# Access Compliance Report

## Public Rights-of-Way

Intersection ID: 46146	Main Street: ROCKY_FORD_CLUB_RD	Cross Street: BEAVER_CREEK_DR	Location: SW
ADA ID: E8BA0A96B56F	Ramp Type: PerpDiag	Initial Pass/Fail: Fail	Overall Compliance: No
Severity Score: 12.5			
Codes/Mitigation Info/Possible Solution		Field Measurements/Component Compliance

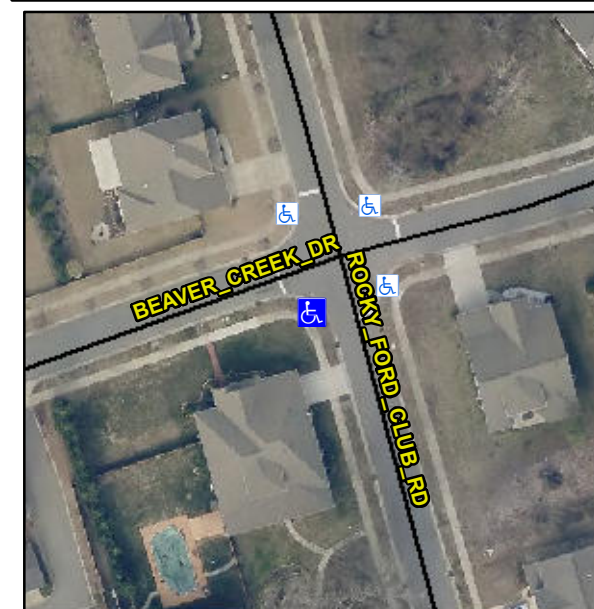
**Not Found, R304.2.2**

Compliance	Description	Data	Compliance	Description	Data
N/A	Ramp Length (in)	79.0	No	Ramp Slope (%)	11.0
Yes	Ramp Width (in)	48.0	Yes	Ramp XSlope (%)	0.1
N/A	Flare Type LT	N/A	N/A	Flare Type RT	N/A
N/A	Flare Slope LT (%)	N/A	N/A	Flare Slope RT (%)	N/A
N/A	Flare Traversable LT?	N/A	N/A	Flare Traversable RT?	N/A
N/A	Landing Length (in)	N/A	N/A	DWS Provided?	N/A
N/A	Landing Width (in)	N/A	N/A	DWS Contrast?	N/A
N/A	Landing Slope (%)	N/A	N/A	DWS Length (in)	N/A
N/A	Landing X Slope (%)	N/A	N/A	DWS Full Width?	N/A
N/A	Landing Curb? (Y/N)	N/A	N/A	DWS Offset (in)	N/A
N/A	Shared Landing?	N/A			
N/A	Gutter Ponding?	N/A	N/A	Gutter Slope (%)	N/A
N/A	Gutter Lip Ht (in)	N/A	N/A	Gutter X Slope (%)	N/A
N/A	Painted X Walk1?	No	N/A	Painted X Walk2?	No
	X Walk 1 Direction	To E		X Walk 2 Direction	To N
N/A	X Walk 1 Width (in)	N/A	N/A	X Walk 2 Width (in)	N/A
	X Walk 1 Slope (%)	2.8		X Walk 2 Slope (%)	0.4
	X Walk 1 X Slope (%)	0.7		X Walk 2 X Slope (%)	0.3

**Remove & Replace Curb Ramp With Two New Directional Ramps or Equivalent.**
